ADDENDUM NUMBER 1

DATE: March 6st, 2024

PROJECT: St. Clair County DTNW – Facility Renovation

PROJECT NUMBER: 0230-0002

CONSTRUCTION PLAN

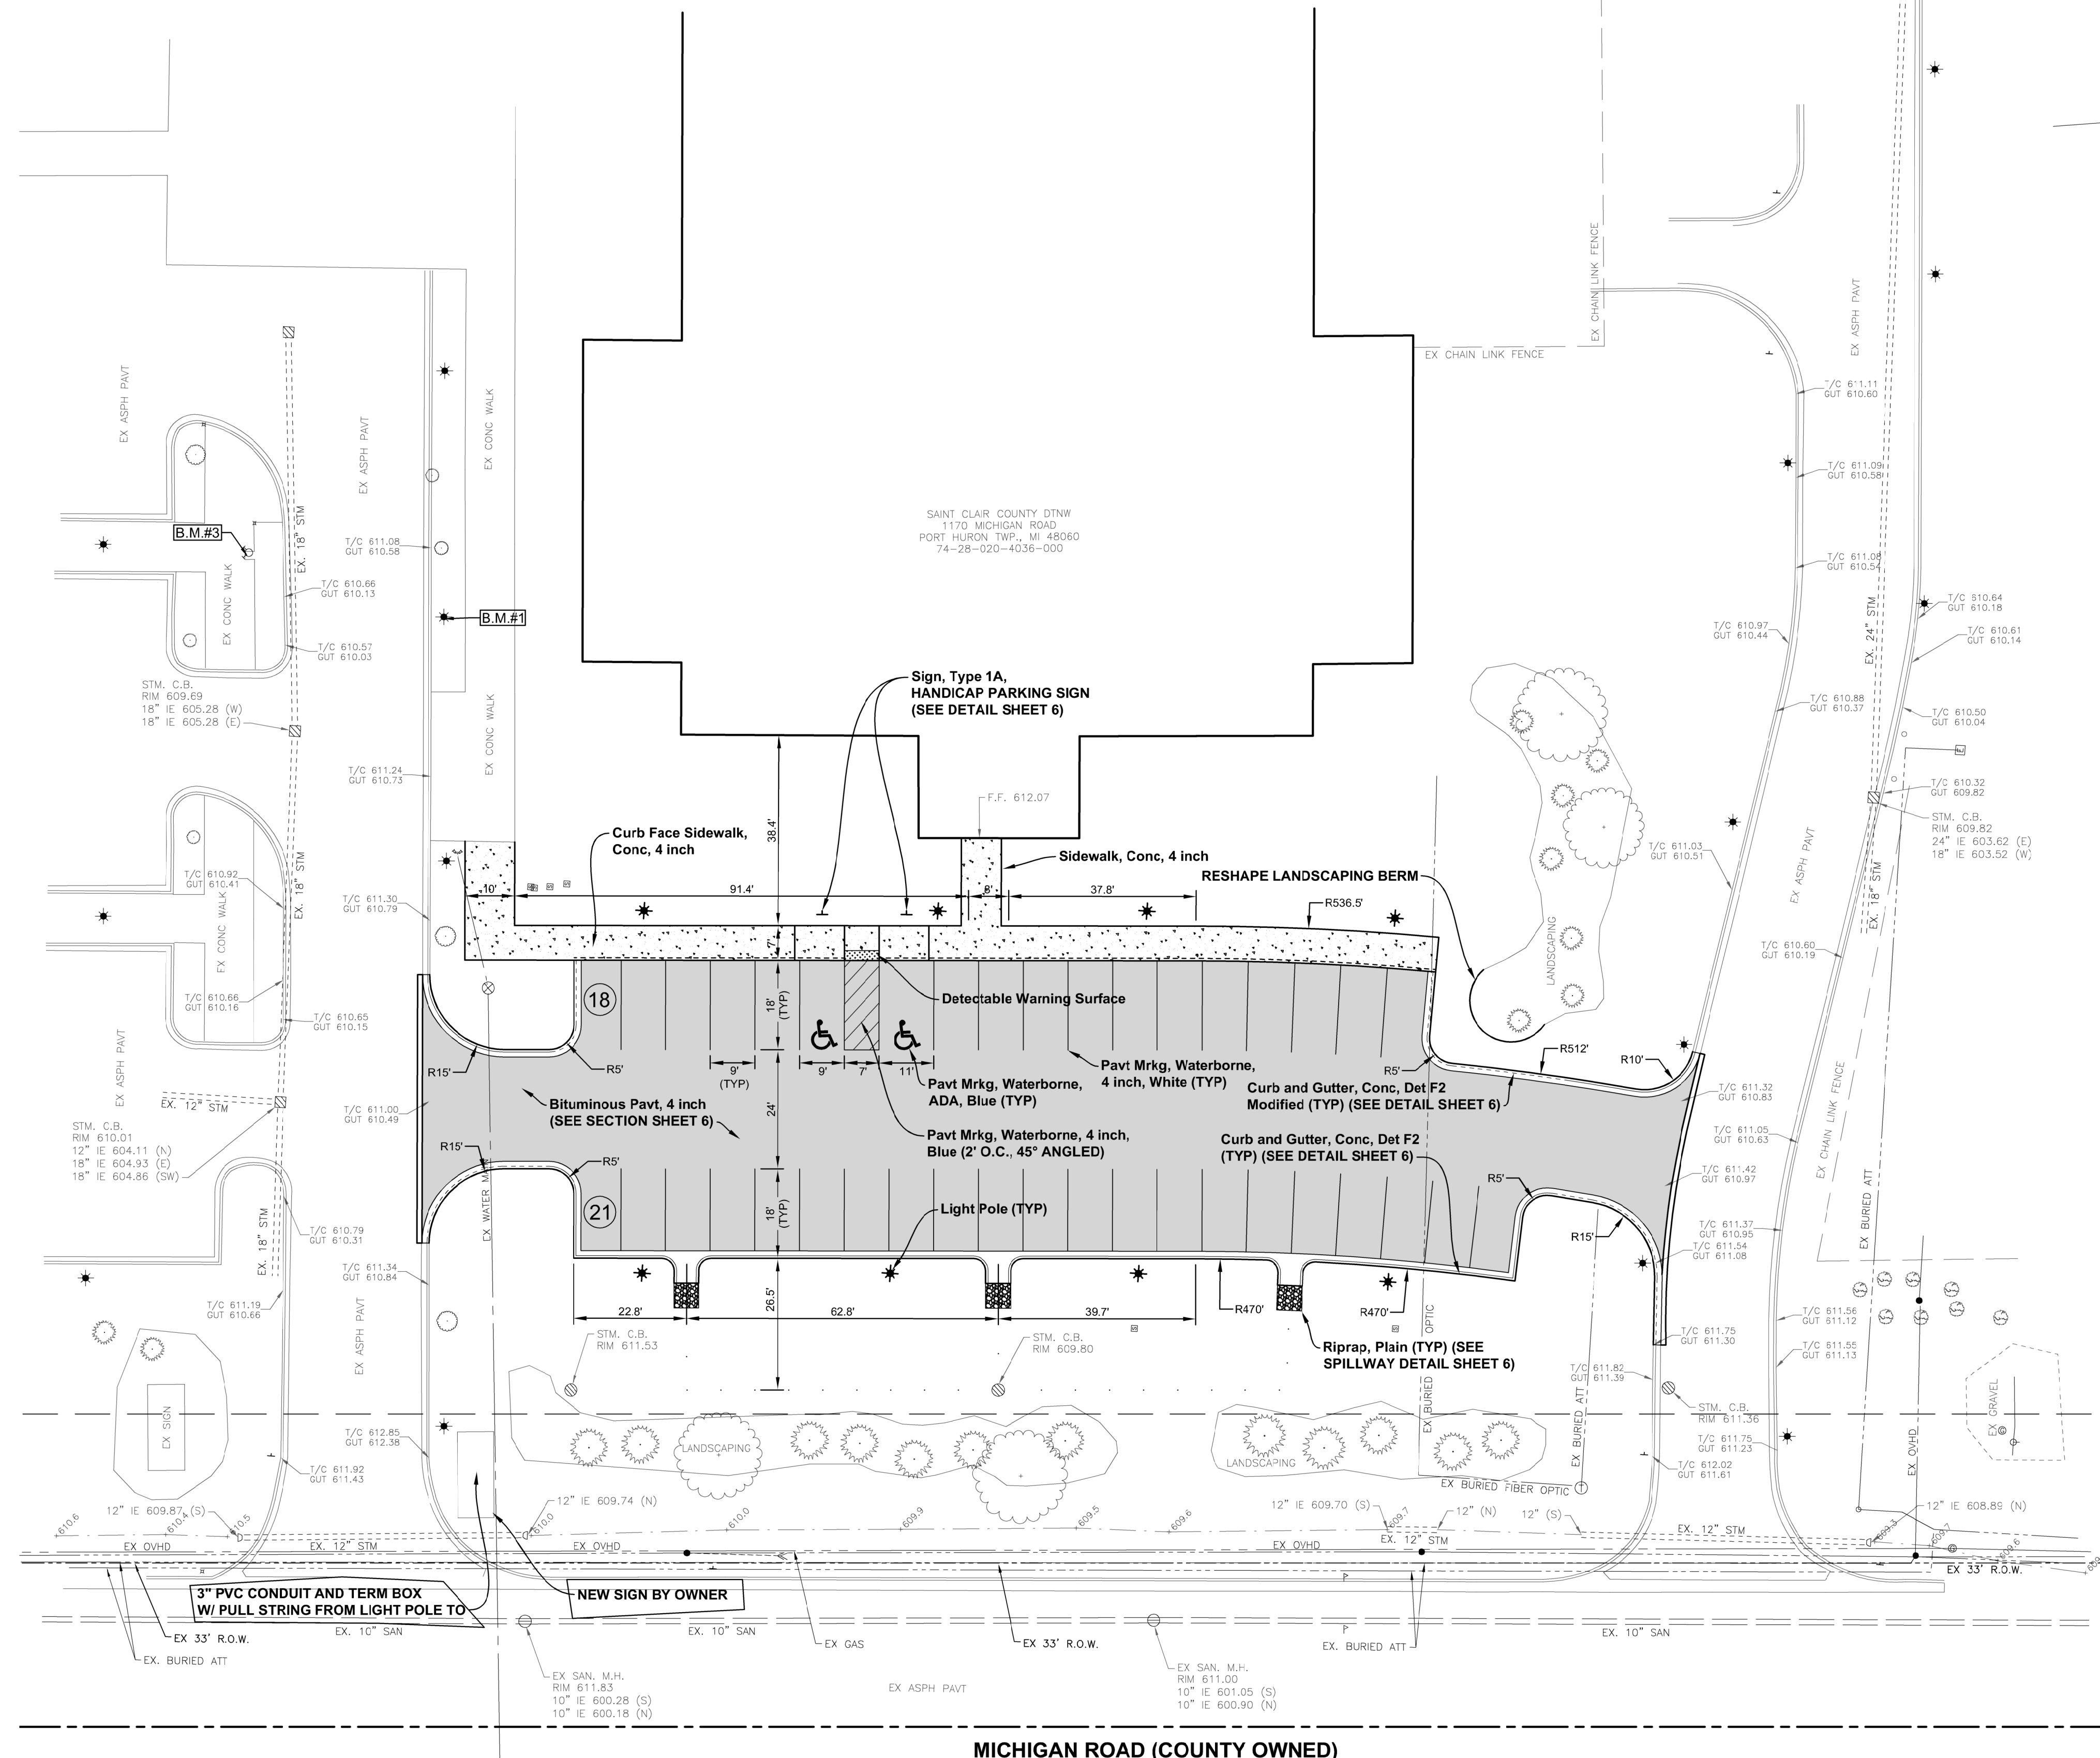
1. SHEET C3:
 - a. Updated note at street sign.
